## MEMORANDUM

**SUBJECT: Title V Permit Renewal; Draft/Proposed Permit: AQM-003/00111-Renewal 2**  
Delaware Solid Waste Authority-Cherry Island Landfill

DATE: March 7, 2012

The following graph shows the yearly average H<sub>2</sub>S concentration (ppm) in LFG for the last 5 years:

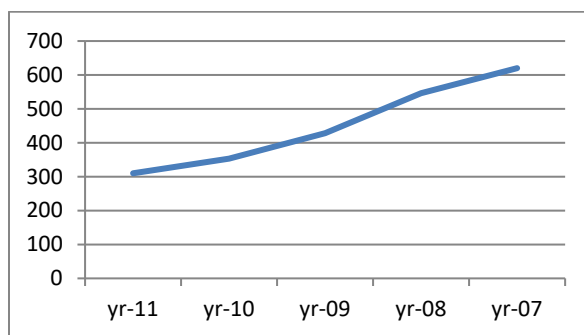
1. Table 8 shows that 490 ppm was the maximum concentration of H<sub>2</sub>S in LFG found in last three years. Based on dispersion modeling results, quarterly H<sub>2</sub>S data for last three years, and my consultation with DAQ management, I recommend 450 ppm be considered the action level instead of 750 ppm proposed by DSWA. I also recommend that the attached permit include the following condition:

*DSWA shall conduct perimeter H<sub>2</sub>S survey (measurement) if H<sub>2</sub>S concentration in LFG exceeds 450 ppm in two consecutive quarters by laboratory analysis (ASTM). The perimeter H<sub>2</sub>S measurements shall be conducted within seventy two (72) hours upon receiving the laboratory results and maintain this information for the Department's reviews. [See Condition 3-Table 1(f)(2)(v)(B) on Page 41]*
